Proposed Comment Resolution for the MR-O-QPSK PHY

IEEE P802.15

Title: Proposed Comment Resolution for the MR-O-QPSK PHY
Date Submitted: January 5, 2011
Source: Michael Schmidt - Atmel (email: michael.schmidt@atmel.com)
Re: Task Group 15.4g LB59 comment resolution
Abstract: Proposed comment resolution for the MR-O-QPSK PHY
Notice: This document has been prepared to assist the IEEE P802.15. It is offered as a basis for discussion and is not binding on the contributing individual(s) or organization(s). The material in this document is subject to change in form and content after further study. The contributor(s) reserve(s) the right to add, amend or withdraw material contained herein.
Release: The contributor acknowledges and accepts that this contribution becomes the property of IEEE and may be made publicly available by P802.15.

AWGN 868.3 MHz, 100 kchip/s, $(8, 1)_{0/1}$ -DSSS and rate 1/2 FEC, 64 octets

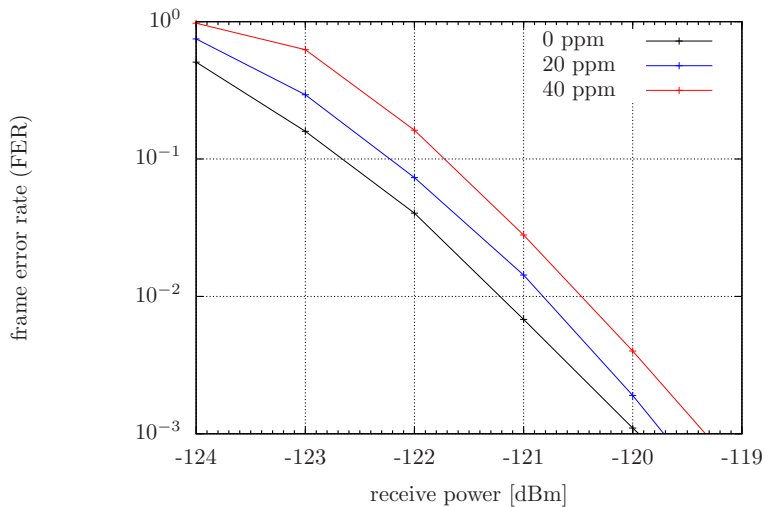
- ▶ Lower data rate should be considered in 470-510 MHz band for improved link budget.
- ▶ Add new data rate of 6.25 kbps with N(8,1)-DSSS and rate 1/2 FEC.

- ▶ For SHR, use $(32, 1)_{k=0}$ -DSSS given in Table 75aa
- ▶ For PHR and PSDU, apply a new spreading code $(8, 1)_{0/1}$ -DSSS with FEC.

- ▶ Add new Tables to section 6.12c.1.9

Minimum Hamming Distance d_{min} :

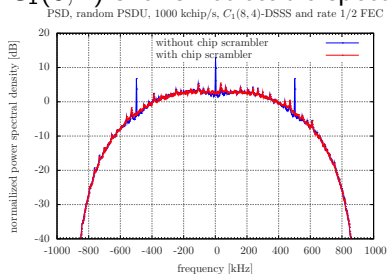
- ▶ Cross correlation of (8,4)-DSSS code is poor
- ▶ Non-coherent detection is not possible
- ▶ Consider (8,4)-DSSS code given in 15-10-0281-04-004g

- ▶ $C_0(8,4)$ is an extended BCH code.
- ▶ The distance properties of the inner block code are less relevant (due to outer rate 1/2 FEC).
- ▶ However, the coding gain of $C_0(8,4)$ can be exploited for a decision feedback based phase control loop³.
